Flight Procedures Cover Page	Task Action: FLIGHT CHECK	Task Type: IAP	Estimated Chart Date: 02/20/2025	APWS Task ID: F8AF8564708B4F4892E8C95988FBB9E0	APWS Project ID: 17DE5C577F434F40A7333511E3E756EE
Procedure: VOR OR TACAN RWY 35 AMDT 1		Enroute: NO	Specialist: Weston, Daniel		Agreement Number:
Airport ID: PHKO			Airport City: KAILUA-KONA		State: HI
Facility ID: KOA	Facility Type: VORTAC	Flight Inspection Remark Type: New FC Slot			
<div>Procedure Comments:</div> <div>PENDING AIRNAV DATA USED.</div> <div>AFS WAIVER LETTER: FAC ALIGNMENT GREATER THAN 5200 FEET OUTWARD FROM THE LTP (8260.3E PAR 5-2-4 a (2a)).</div> <div>AFS APPROVAL LETTER: PUBLISHING VDA LESS THAN VGSI (8260.3E, PAR 2-6-2b).</div> <div>CONTACT RAKE MCGRAW, AJV-A422 405-954-8711.</div> <div>01/13/2025: THIS IS AN UPDATED COPY OF THE FORM DEVELOPED ON 08/13/2024.</div> <div>1. CHANGED REQUIRED EFFECTIVE DATE FROM ROUTINE TO 02/20/2025. -HARD DATED</div> <div>QUALITY 16 CHECKED</div> <div>QUALITY 38 CHECKED</div> <div>QUALITY 25 CHECKED</div>

VOR or TACAN RWY 35
ELLISON ONIZUKA KONA INTL AT KEAHOLE (KOA) (PHKO)

Subject: Approval Request: ELLISON ONIZUKA KONA INTL AT KEAHOLE (PHKO), VOR
OR TACAN RWY 35

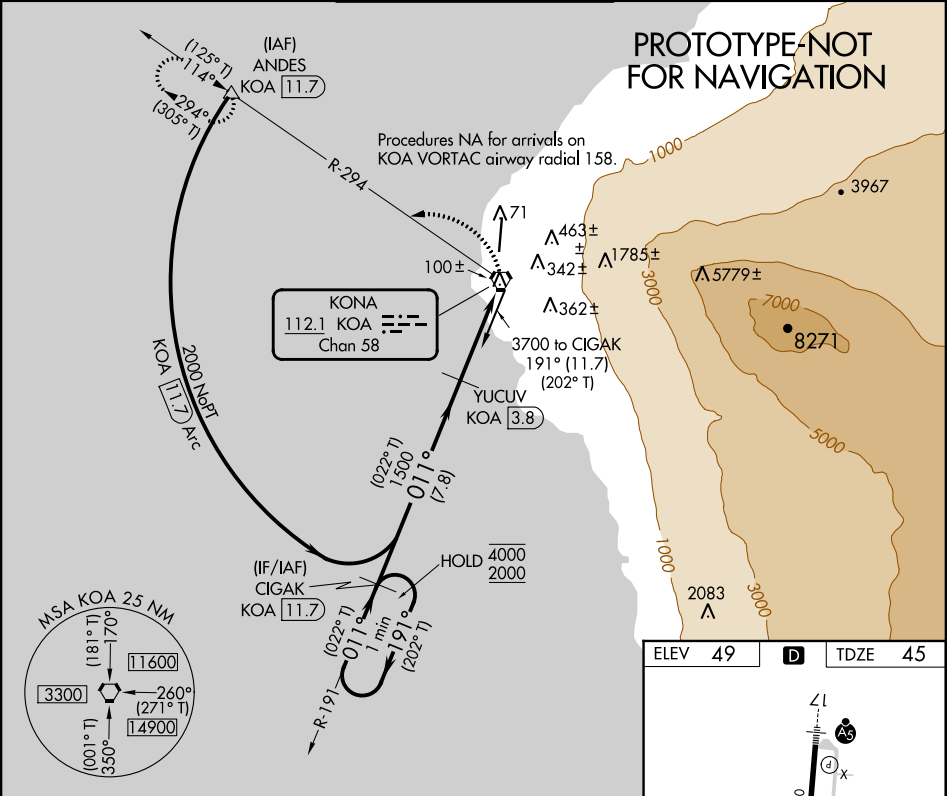
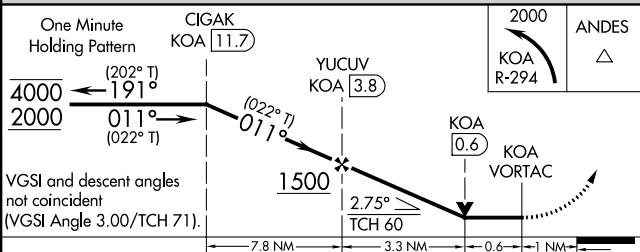
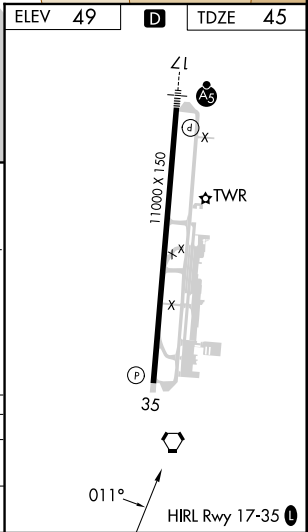
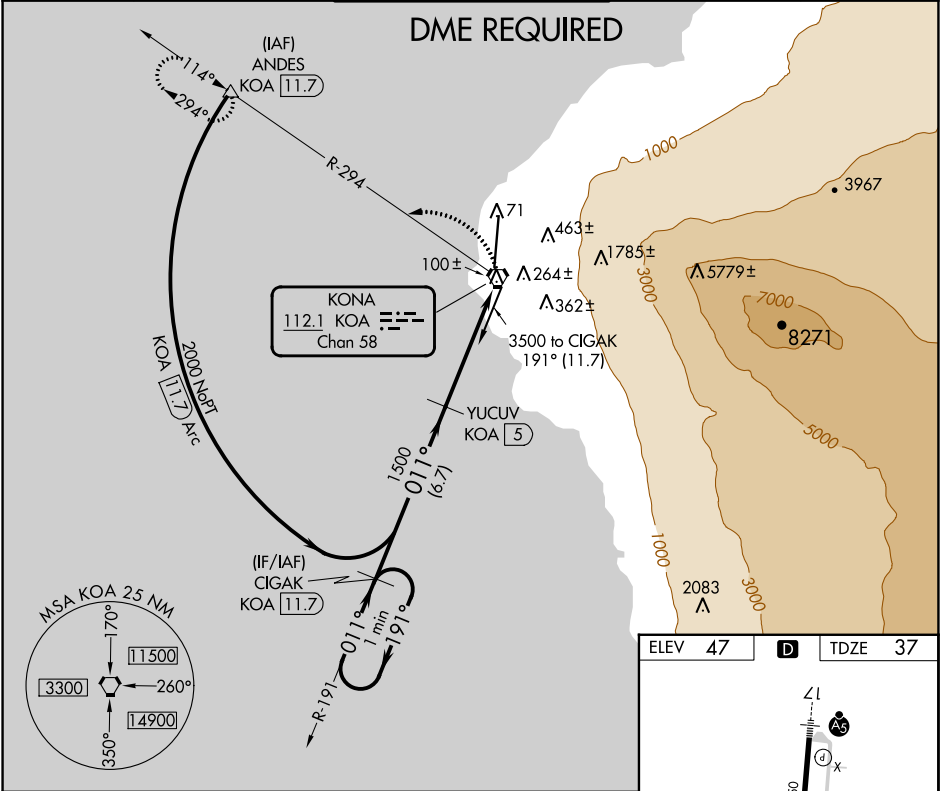
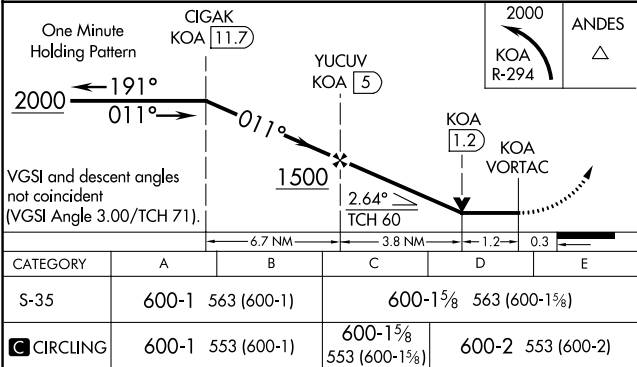
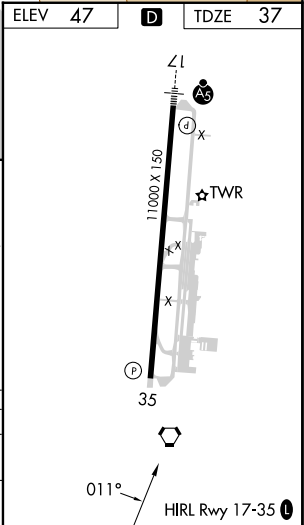
Request to publish the VOR or TACAN RWY 35 procedure where the final intersects the centerline extended 9181.84... ft from the LTP, which is greater than the maximum authorized distance of 5200.0 ft. The runway 35 threshold is being temporarily relocated 4000 FT north to accommodate required runway reconstruction. Due to the location of the KOA VORTAC in relation to the currently published runway 35 threshold, the VOR or TACAN RWY 35 procedure crosses RWY C/L extended 5194 FT from THLD and meets on-airport criteria requirements. When the threshold is relocated 4000 FT for approximately one chart cycle to accommodate reconstruction, the extended distance increases to 9181.84 ft and move the facility to an off-airport facility not meeting criteria requirements. This will be a temporary situation that will accommodate continued operations during construction when wind or opposite direction operations will not be feasible.

This is a temporary Waiver until publication of the amended VOR OR TACAN RWY 35 is published when the Runway 35 threshold is returned to its original location and the point of intersection returns to 5194 ft satisfying the requirements of 8260.3E Para 5-2-4 a (2) (a).

1. Minimum MDA 600 FT will be maintained and visibility will be increased for CATS A/B by a 1/4 SM.
2. The Final and Missed Approach Obstacle Clearance Surfaces (OCS) have been evaluated to an extended area where they incorporate coverage of the nearest portion of the usable landing surface of the runway.
3. The minimum visibility has been raised to ensure that the minimum visibility is high enough for the pilots to obtain the proper visual references required for landing.

VOR OR TACAN RWY 35

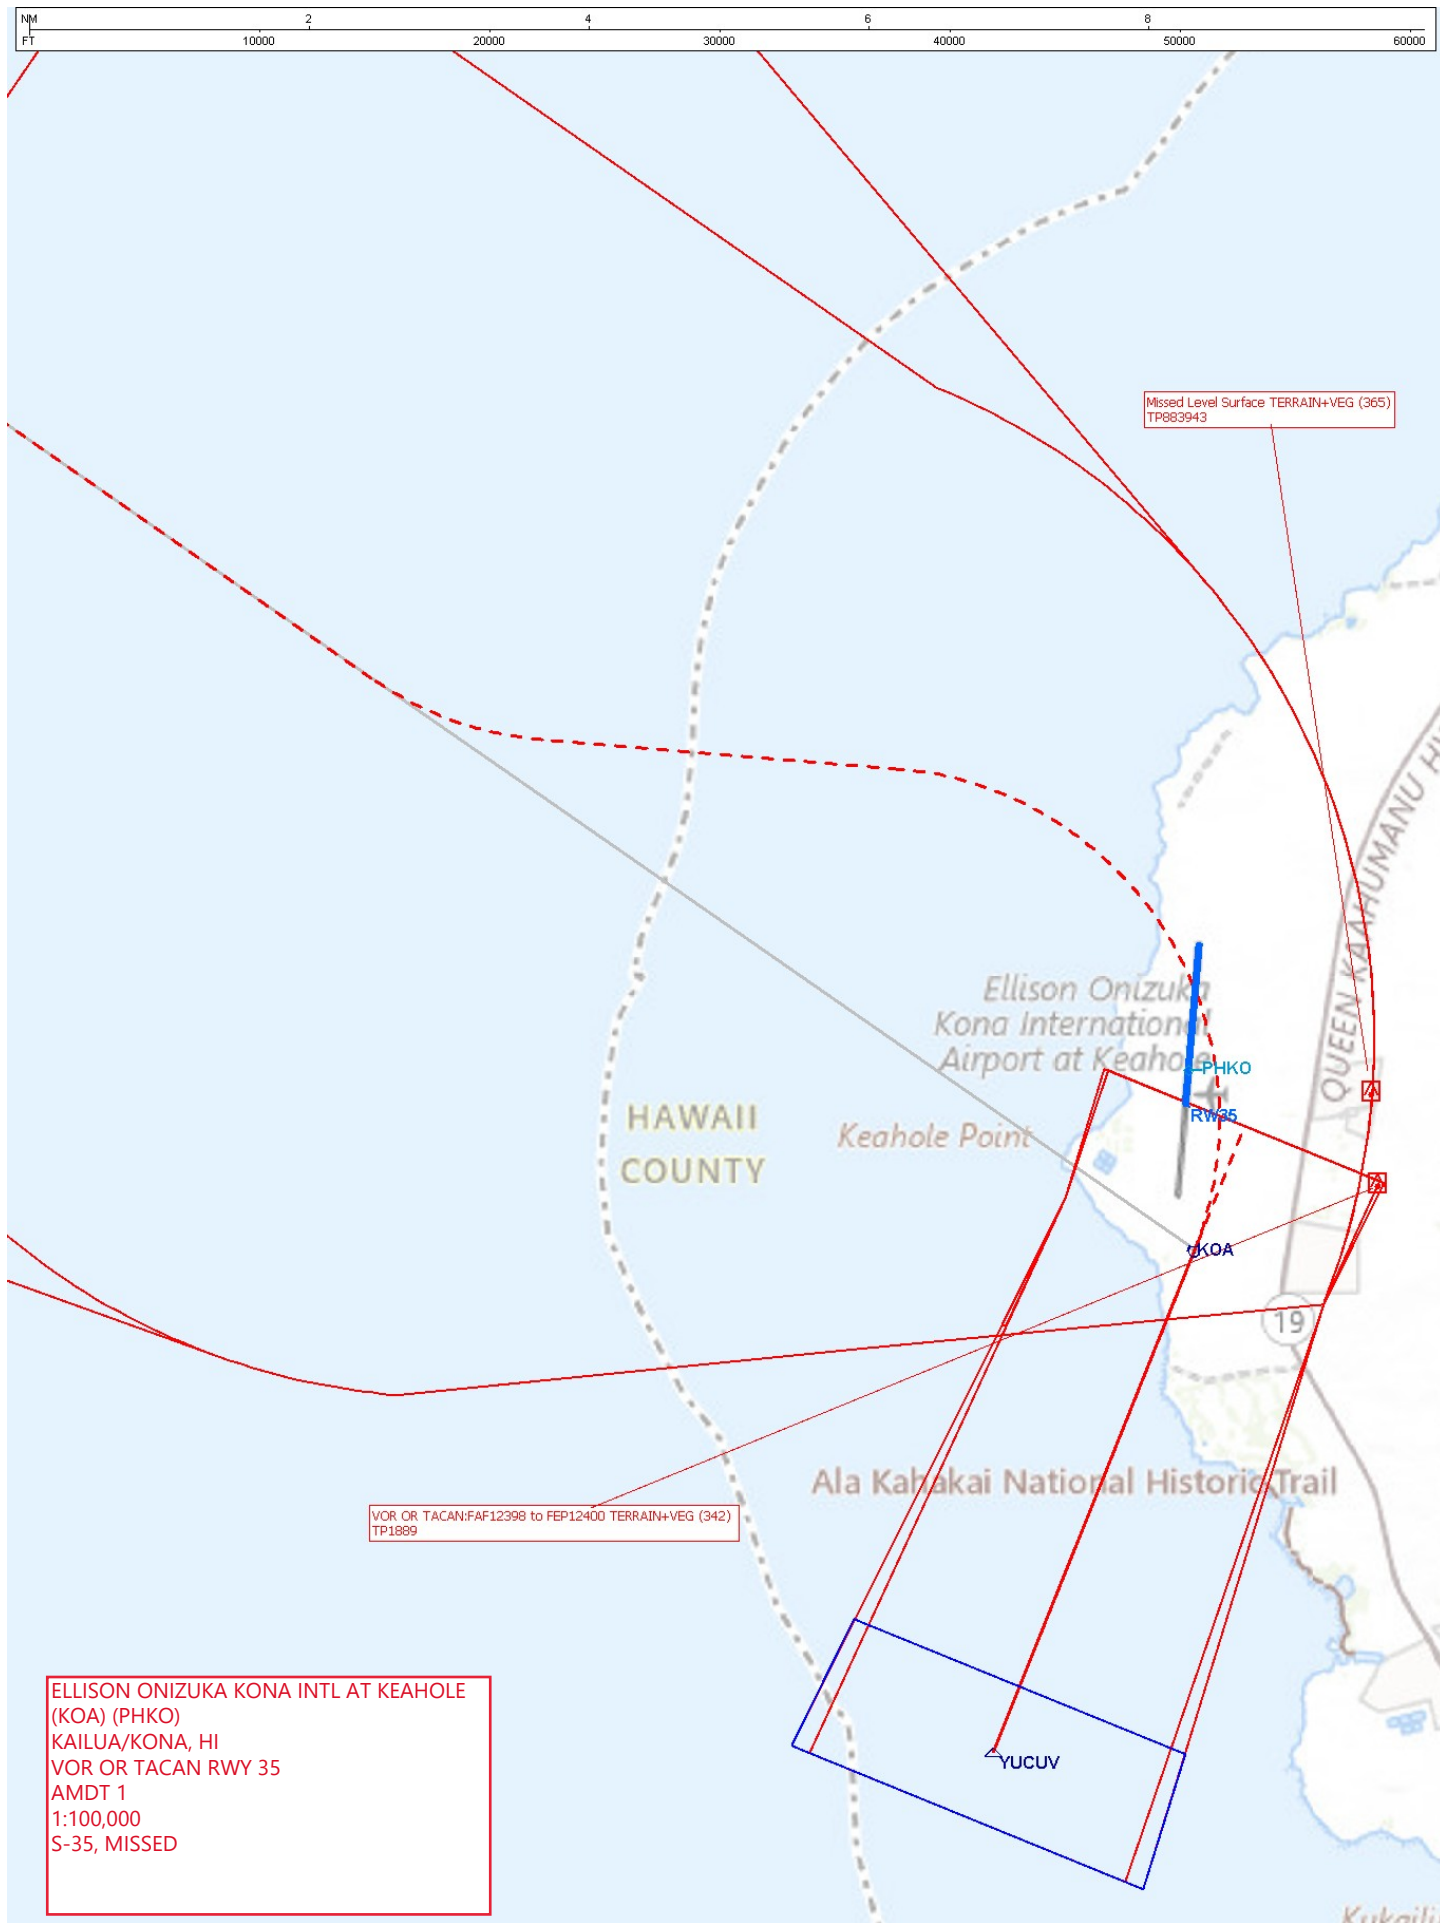
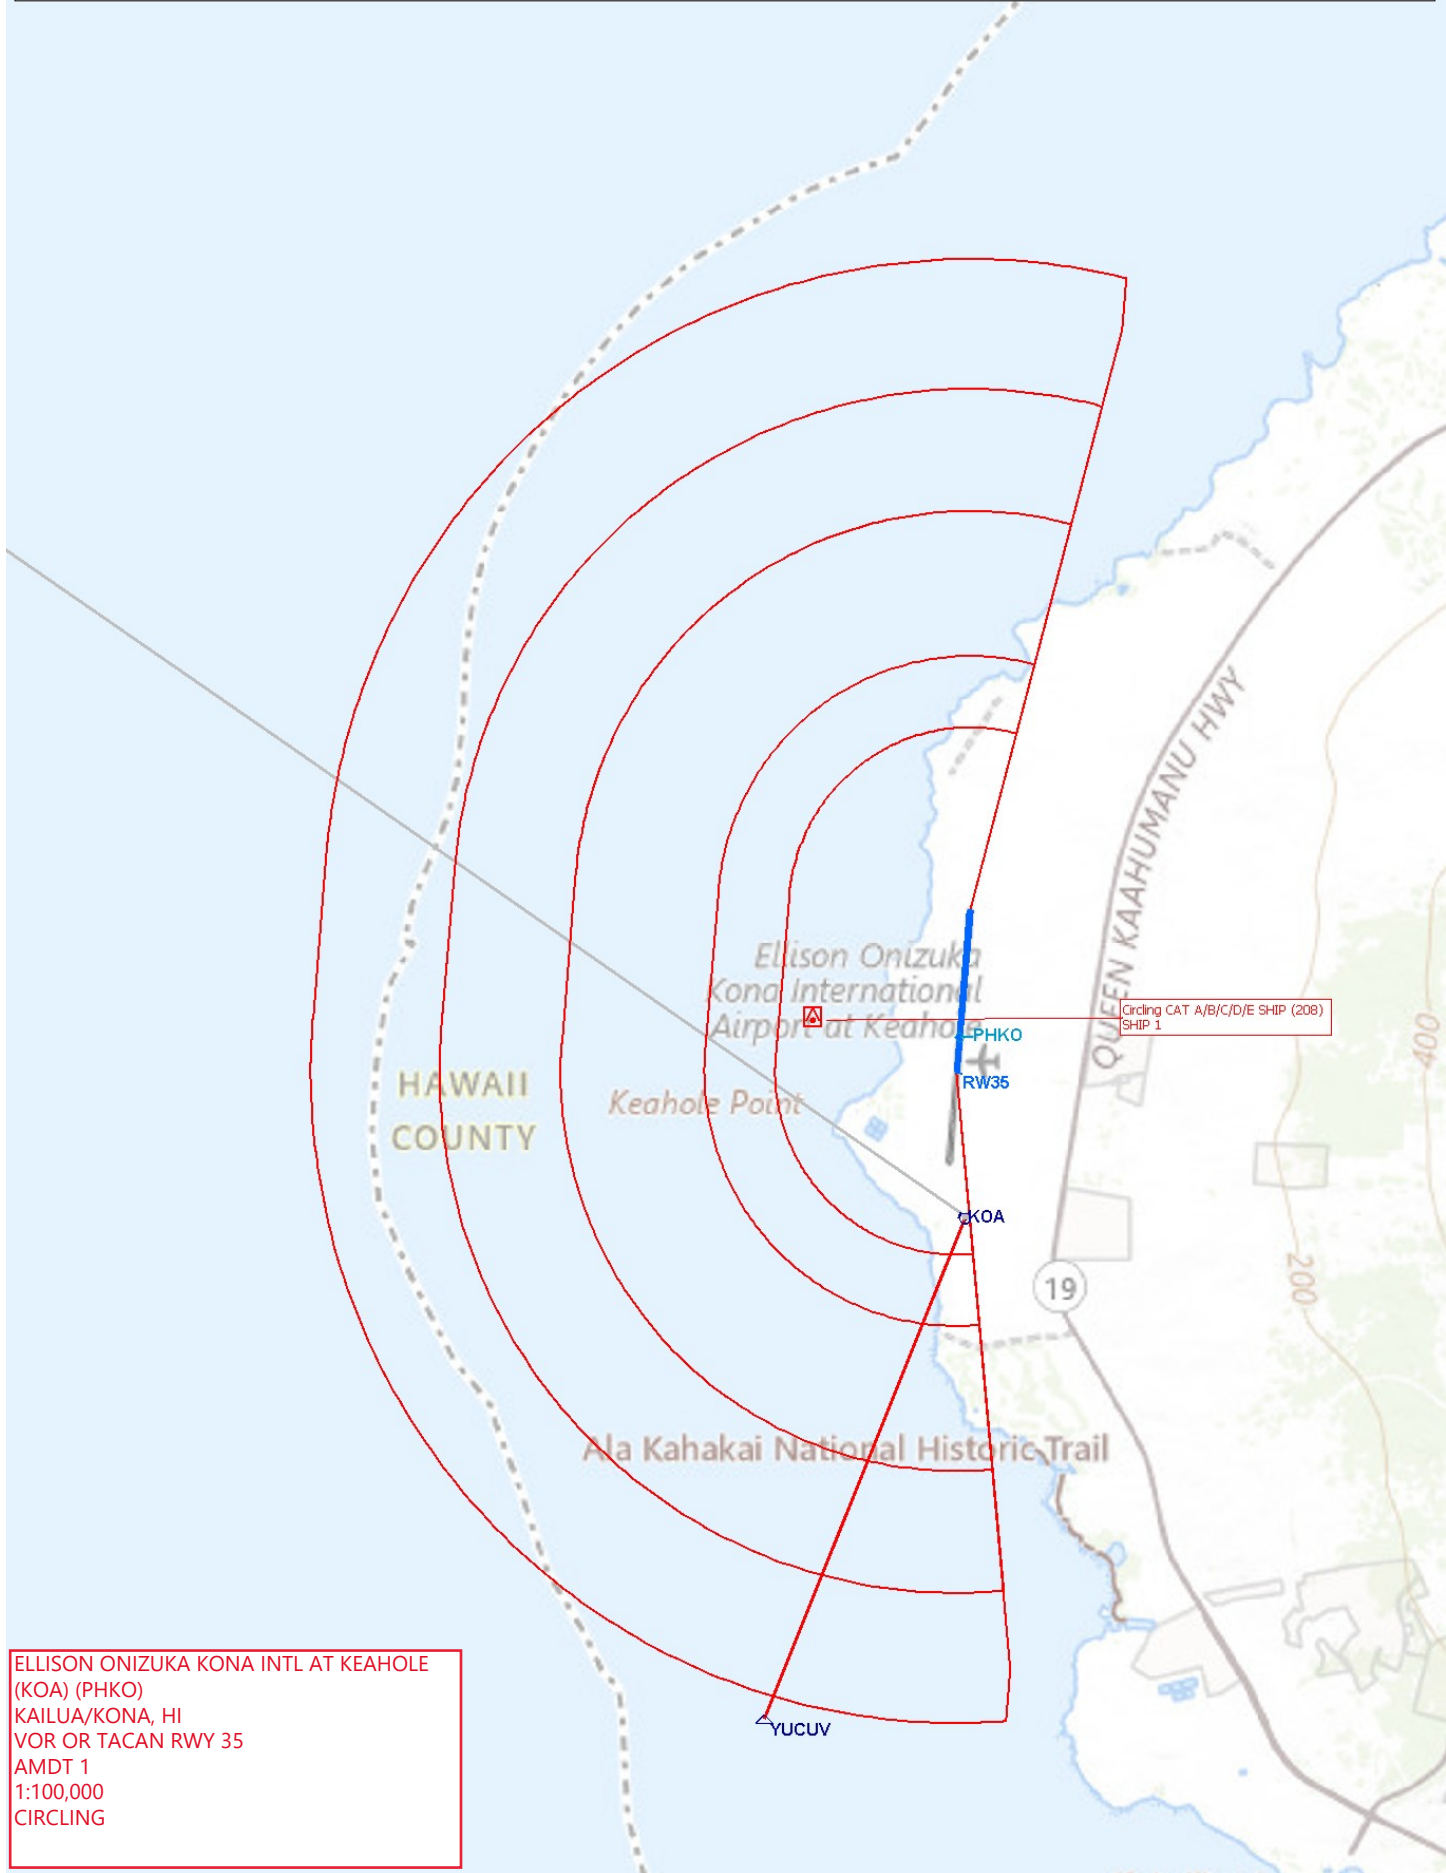
Procedural VDA/TCH is 2.642/60.0 and published VGSI is 3.00/71. Chart note "VGSI AND RNAV GLIDEPATH NOT COINCIDENT (VGSI ANGLE 3.00/TCH 71)" will be published.

VOR OR TACAN RWY 35 ORIG-D is currently published at VDA/TCH 2.64/60.0 and VGSI is 3.00/71. PHKO has a three phase runway construction until 10/2/2025 and plans are in place to eliminate the temporary increase to 2.75/60.0 VDA due to a TARGETS flag. A 3.00/60.0 VDA will be published during the final phase of runway construction. Request to publish a temporary VDA of 2.75/60.00 until phase III construction.
